Hi-Fi Products
Service Bulletin

Model: TAN-611

No. 263

Subject: Unit Goes Into Protect Immediately Following Power-up. **Date:** April 27, 1992

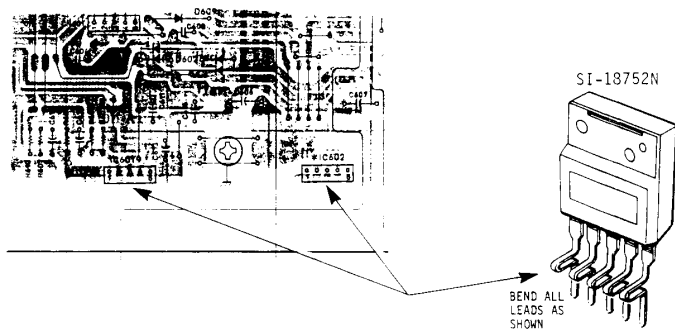
Symptom:
(51) When unit is powered on, the speaker relay turns on and audio is heard from the front speakers for a brief instant before the unit goes into protect.

Solution: The problem is due to broken solder connections on IC601 and IC602. This is caused by excessive movement between the PC board and mounted components IC601 and IC602. Remove IC601 and IC602 and provide strain relief by bending leads as shown in diagram below. If the leads are too short, replace IC601 and IC602 with new parts and bend leads as shown in diagram.

REF. NO.	DESCRIPTION	PART NUMBER
IC601/602	SI-18752N REAR CHANNEL AMPLIFIER IC	8-759-502-32
